DOMINION VIRGINIA POWER
NORTH ANNA UNIT 3 COMBINED LICENSE APPLICATION
SRP 09.02.01: REVISED RESPONSE TO RAI LETTER 65

Revised Response to NRC RAI Letter No. 65

RAI No. 5554, Question 09.02.01-14

QUESTION NO.: 09.02.01-14

Figure 1

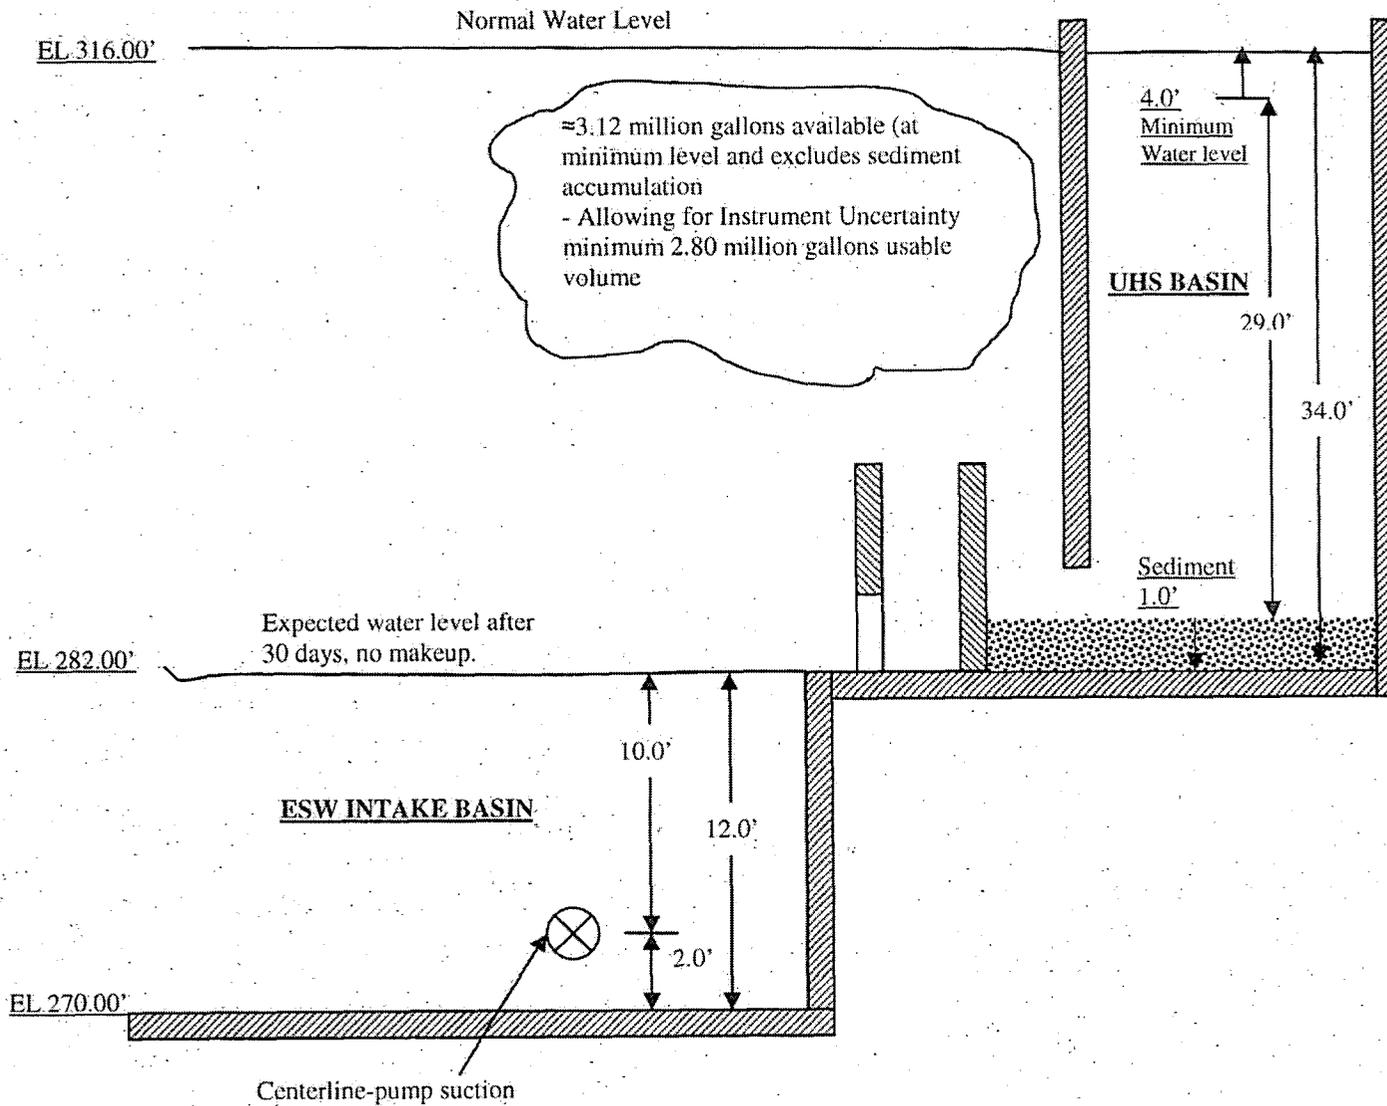
- Discuss pump vortex formation as part of the NPSH evaluation.
- Provide drawings indicating the elevation of the ESWS pump impellers.
- Include in the FSAR the low water level in the UHS to support adequate NPSH.

- Provide a clarification to the following FSAR sections related to basin level to support NPSH. FSAR Section 9.2.1.2.2.1, "ESWPS" describes the available NPSH with the lowest expected water level (after 30 days of accident mitigation) in the basin to be approximately 12.2 meters (40 feet). However the UHS basin level is described as 8.8 meters (29 feet) deep in FSAR Section 9.2.5.3, "Safety Evaluation".
- Provide in the FSAR the bases for the ESWS pump total dynamic head (TDH) of 67.1 meters (220 feet) and describe the margins available for the pump as related to system losses. Include in the FSAR a discussion related to TDH, flow requirements and time durations to the fire protection system that supports the reactor building and essential service water pump house.

- The attached Figure 1 depicts the cooling tower basin structure elevations of interest including the ESW pump impeller. The ESW intake basin floor elevation is 270 feet, and the UHS basin floor elevation is 282 feet. The normal operating water level is 316 feet. The minimum operating water level is 312 feet. The impeller (eye) of the ESW pump is located approximately 2 feet off of the ESW intake basin floor at an elevation of 272 feet. A vaned basket is installed at the suction of the vertical ESW pump. The actual ESW pump impeller elevation is subject to the final design details.

The 29 feet water depth in the UHS basin described in FSAR Subsection 9.2.5.3 is used to calculate available usable water volume (allowing for sedimentation and measurement uncertainties) from the low water level alarm point. Figure 1 provides the elevation and sediment information to illustrate the 29 feet water level in the UHS basin.
